Core Bus Corridor 13: Bray - Preliminary Submission

1.0 Introduction

3.2.2.3 Outbound Traffic

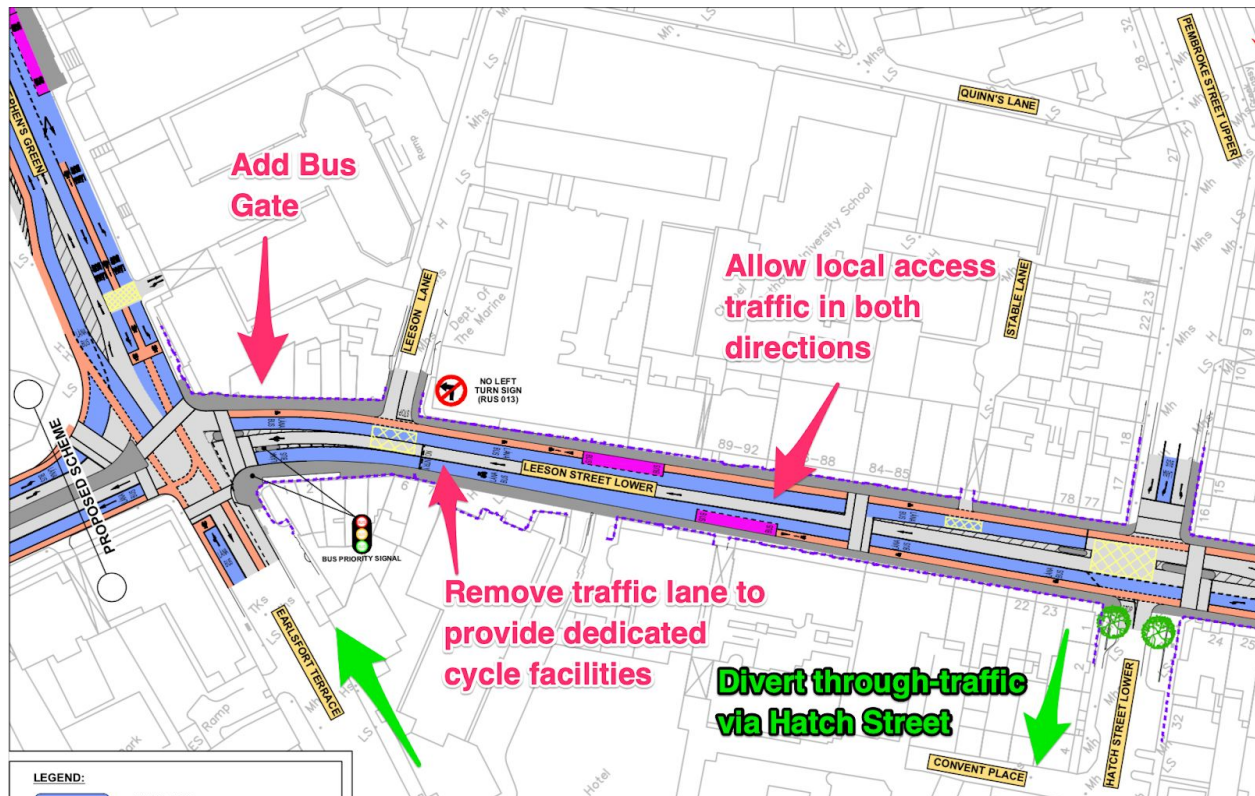
The narrow streaming lane for cyclists leading to the Leeson St junction is extremely dangerous for cyclists, and we believe that it requires safer access to it and greater protection for cyclists. The fact that flexible bollards had to be installed at this junction not long after it was installed should be sufficient evidence that this design is not safe for cyclists. A possible alternative design for this cycle route would be to keep the cycle track to the left of the bus lanes, provide greater lane width, and give cyclists continuing straight or turning right a separate green phase to buses turning left.

3.4 Leeson Street Upper/Sussex Road

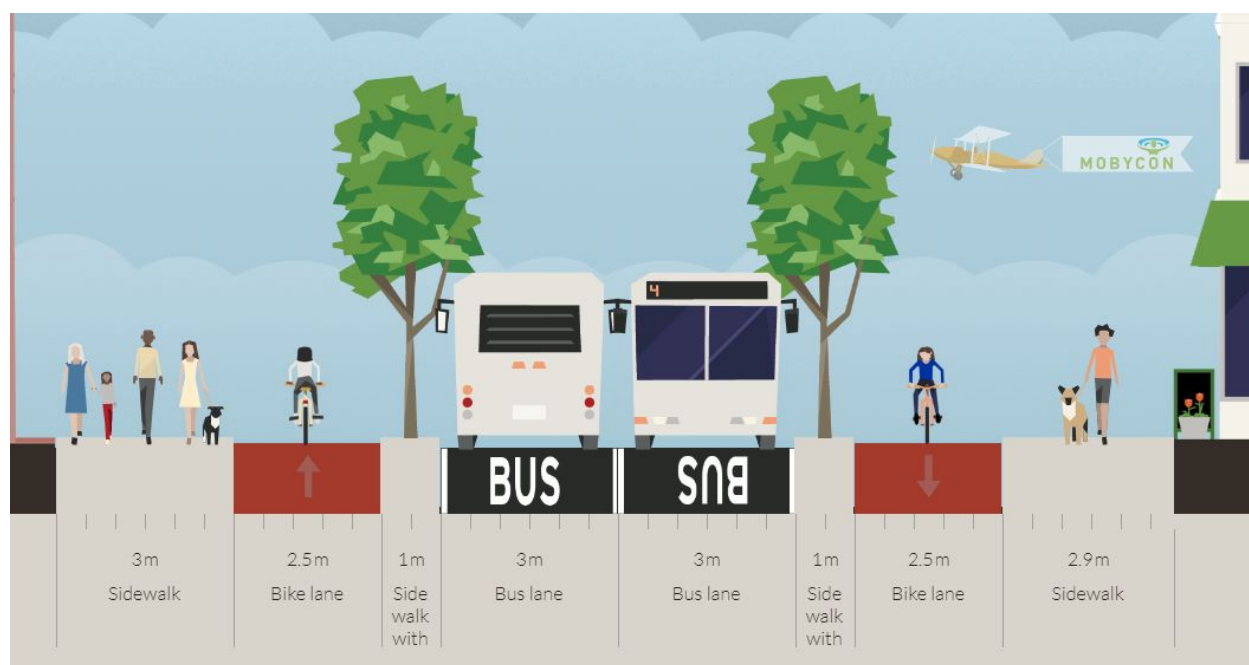
The removal of a traffic lane on this stretch of road is a welcome proposal, but it is disappointing that this extra space is not being effectively used to deliver high quality cycle tracks, including island bus stops, buffer area, and parking protected cycle tracks.

Option 1E2, A-A Cross Section

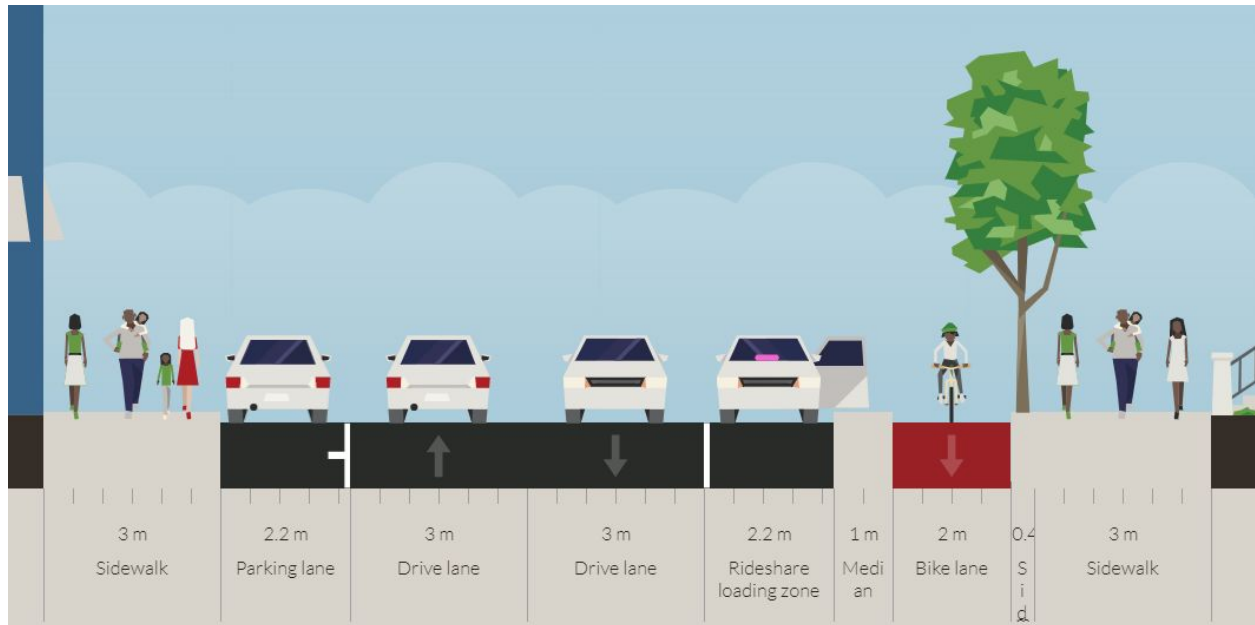
For example, on the A-A section of option 1E2, the footpath could be widened a little less, and the cycle lanes could be upgraded to fully segregated cycle tracks behind the trees. On the B-B section, the cycle track could be widened and placed between the taxi rank and the footpath. For option 1E3, similar improvements could be made.

The cross sections below show how options 1E2 and 1E3 should be designed to provide high quality cycling infrastructure. With very minimal changes to the designs, these cross sections are superior to any of those proposed in the options report.

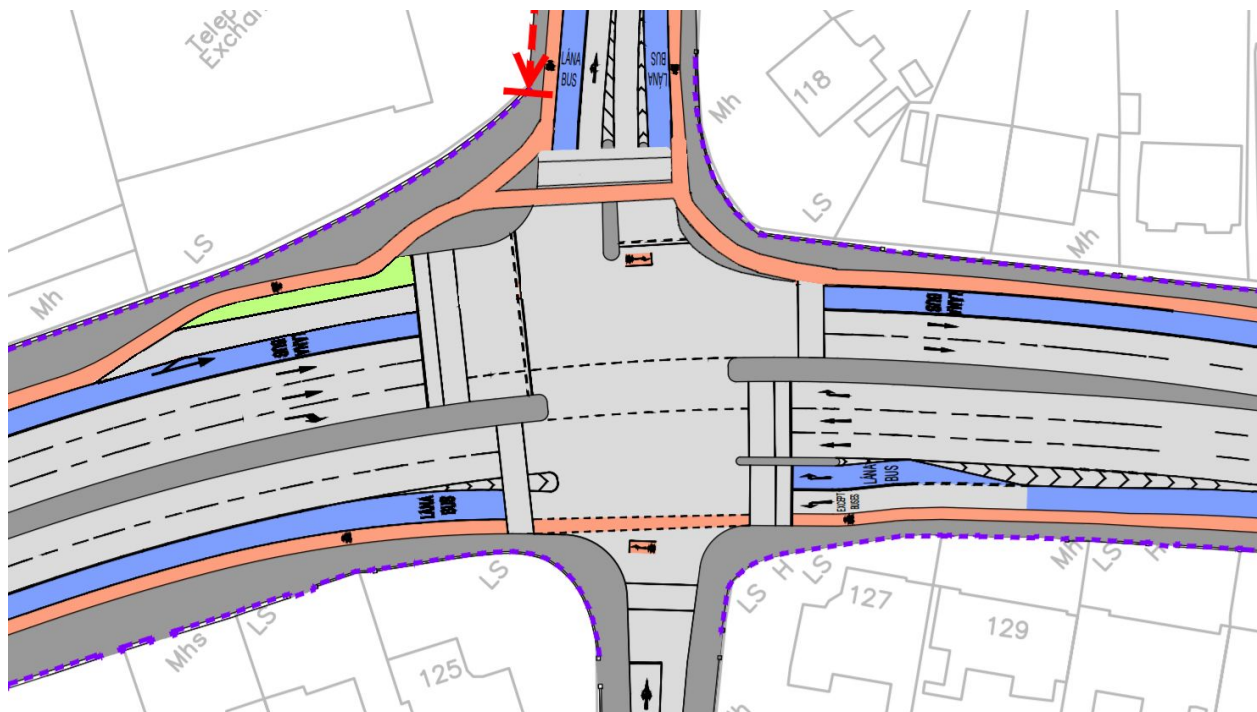
The slip lane at The Court on map 11 should be removed and replaced with a standard T-junction. This slip lane encourages motorists to exit across the cycle track at speed. The slip lane also increases pedestrian crossing distance.

Currently, the inbound cycle track crosses these minor roads. We recommend that the cycle track remain level, without dips across these roads, specially as the cycle track is downhill.

Extract of map 15

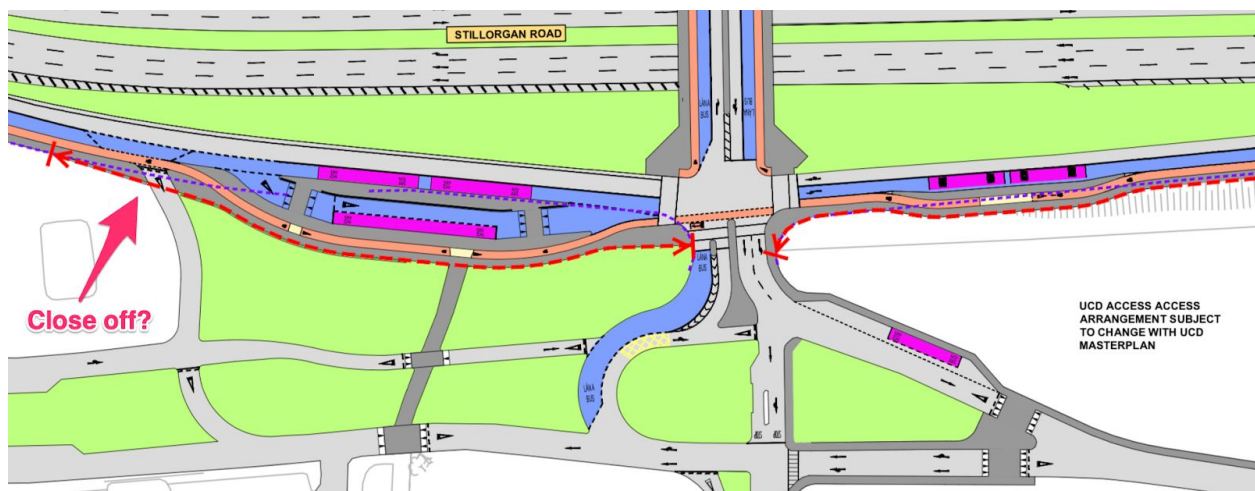
1. The cycle tracks on the flyover should continue into the junction and be more direct, rather than merging into shared space. Shared space is dangerous for cyclists and pedestrians, and there is more than enough space to avoid using it here.
2. Ideally, the UCD exit lane to the north of the flyover should be closed off to motor traffic. This would remove a conflict point between cyclists and motor vehicles and provide an intuitive route for cyclists to exit UCD and join the inbound cycle track

Extract of map 17

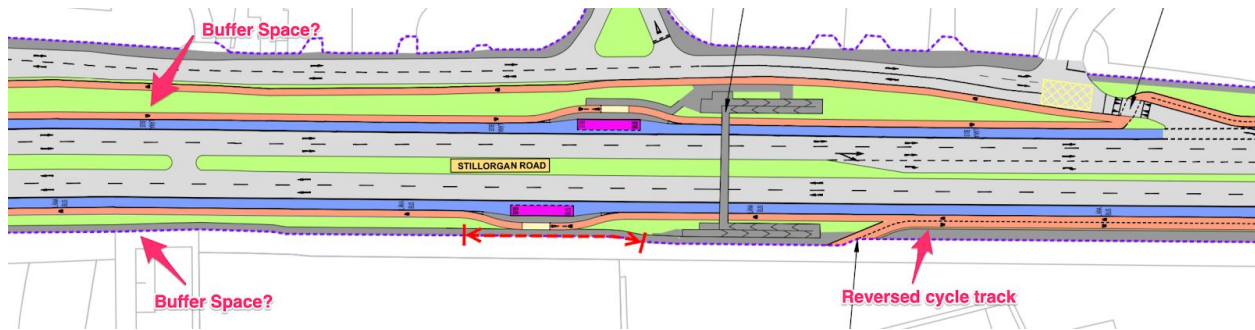
The 2 separate cycle tracks on the East side of Stillorgan Road between UCD flyover and Fosterbrook should ideally be merged into a single 2 way cycle route. This would allow more economic use of the available green space. There is also an opportunity to provide a buffer space between the cycle track on the western side and the Stillorgan Road on map 16 and map 17. This buffer space would increase the safety of the route and the two-way cycle track from Fosters Avenue to the new UCD entrance could be un-reversed so that cyclists can cycle on the left.

3.12 Fosters Avenue Junction

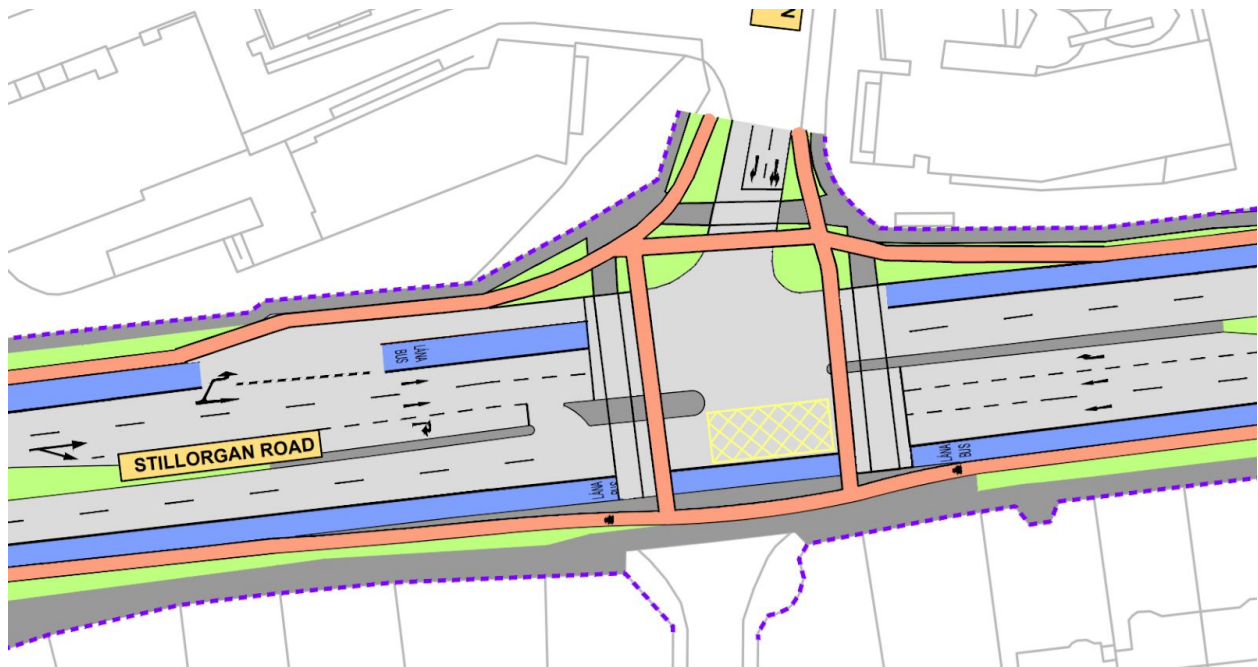
The Foster's Avenue/The Rise junction area has recently gone through a comprehensive Part 8 design, and is proposed to be upgraded with improved cycling and pedestrian facilities. We suggest that this Part 8 is the design that should be used and not the one proposed here. The cycle track should stay to the left of general traffic, and left turning cars should get a different green phase to traffic continuing straight.

3.16 Underpass

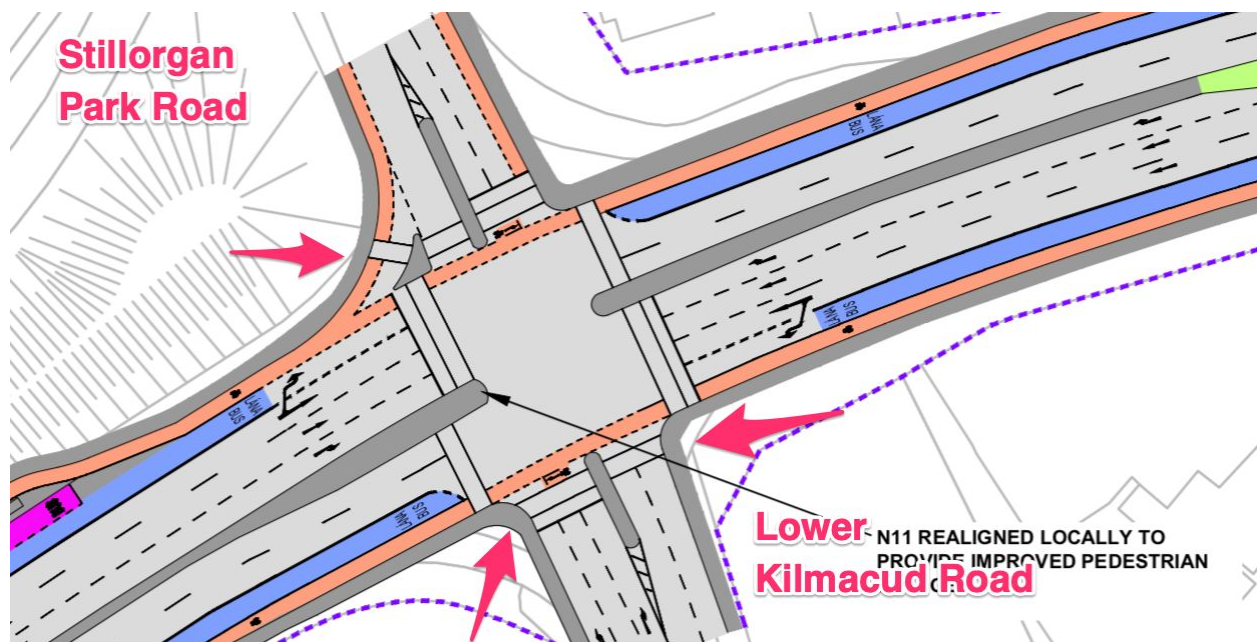
We recommend working with Dún Laoghaire Rathdown county council on their planned upgrade of library facility and public realm around the underpass. It should be made easily accessible by bike from both sides.

Extract of map 38 showing alternate cycle track location that provides a buffer space between left-turning traffic and the cycle track

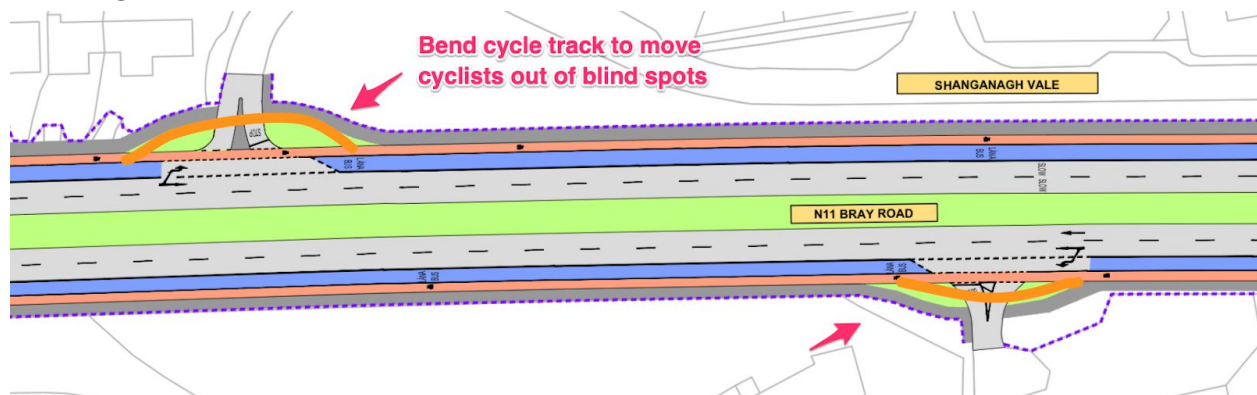
There are a number of side entrances on maps 38 and 39 that would be ideal for a buffered turned design (section 2.7.2 above) given there is a large amount of space. See diagram below.

3.27.1 Access to Loughlinstown Hospital

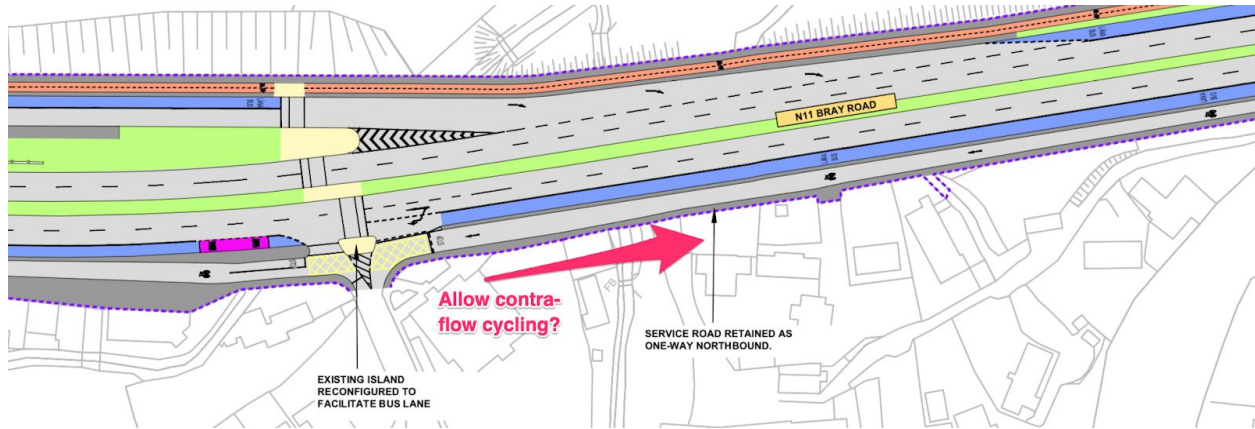
It is also unclear how someone on a bike heading south can safely access Loughlinstown Hospital or the residential estates of Rathmichael Manor and White Gables. This requires design clarification and a possible contraflow cycle route

Extract of map 54 showing gap in cycle track

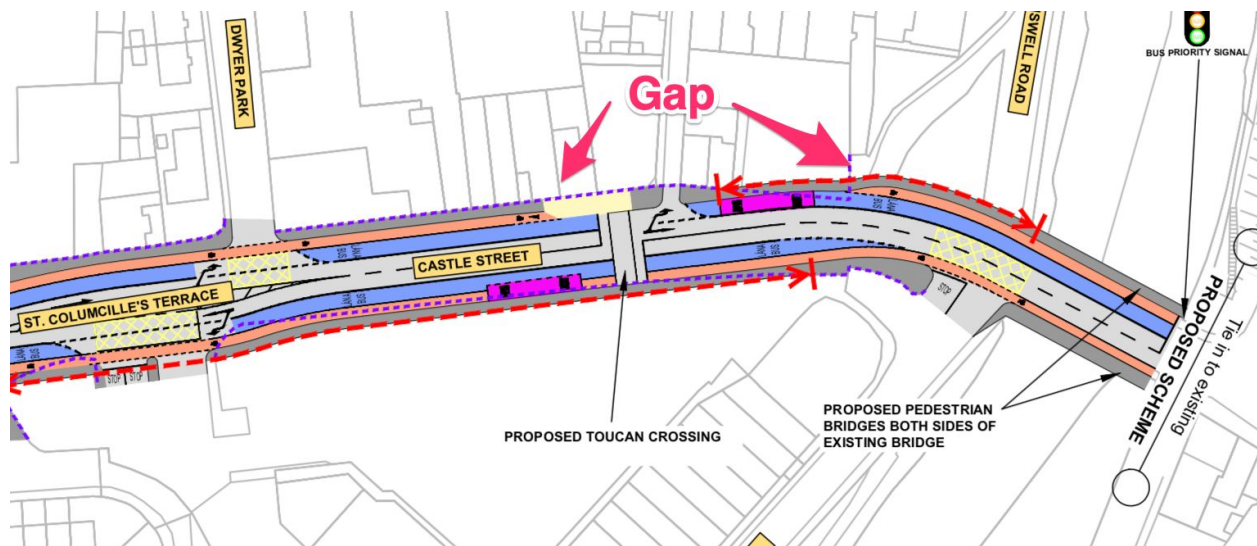
There is an unfortunate gap in the proposed southbound cycle track on Castle Street (map 54). This seems unnecessary as there is proposed CPO of the car park on the opposite side of the road. The CPO should be extended to include enough space to build a continuous cycle track. This might have implications on access arrangements to the shopping center, but this access could be made one-way if necessary.
